AUTO CARE CENTER

14602 WASHINGTON AVENUE, SAN LEANDRO CA. 94578
 OWNER: 2950 MERCED PARK PROPERTIES, LLC
 Charles Travers/ Gayle Travers
 296 Via La Paz, Greenbrae, Ca.
 APN # 77C-1310-9-1

September 30, 2015 - B15-1319
 Engineering and Transportation Review
 By Phillip Toste, Assistant Engineer - 510-577-3375
 Approved with Conditions

SHEET TITLE:
COVER SHEET

PLOT PLAN

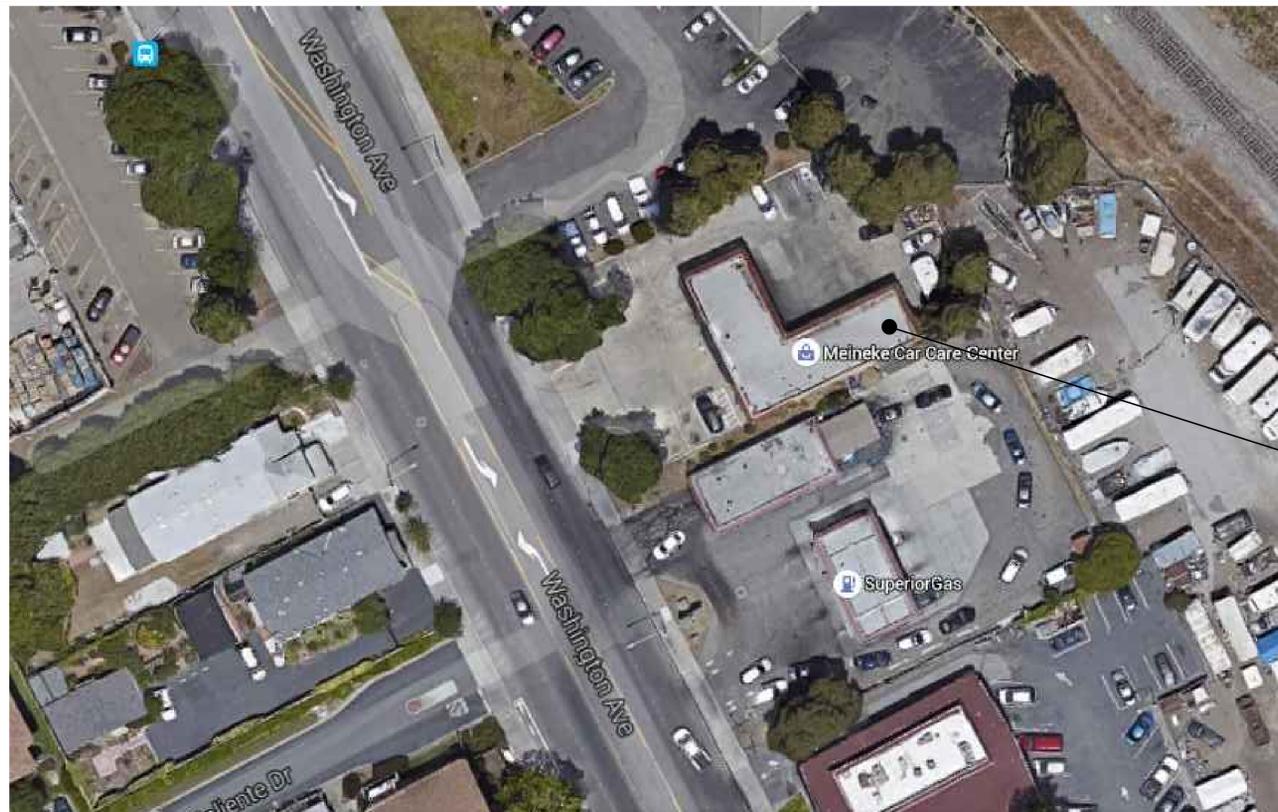
1. The applicant shall remove any unused driveways or damaged driveways, sidewalk, and curb and gutter along the full property frontage and shall construct new City standard driveway, sidewalk, curb and gutter in place of the removed items.

2. The applicant shall obtain an Encroachment Permit from the Engineering and Transportation Department and pay encroachment permit fees for any work within the public right-of-way. The applicant must obtain the Encroachment Permit prior to building permit issuance.

3. Applicant shall comply with the following high standards for sanitation during construction of improvements: Garbage cans, construction dumpsters, and debris piles shall be removed on a minimum weekly basis. All food related trash items such as wrappers, cans, bottles, and food scraps shall be disposed of in closed containers only and shall be regularly removed from the site. Inspections, conducted as part of the regular construction compliance, will be conducted to ensure compliance of the Applicant and contractors with this requirement
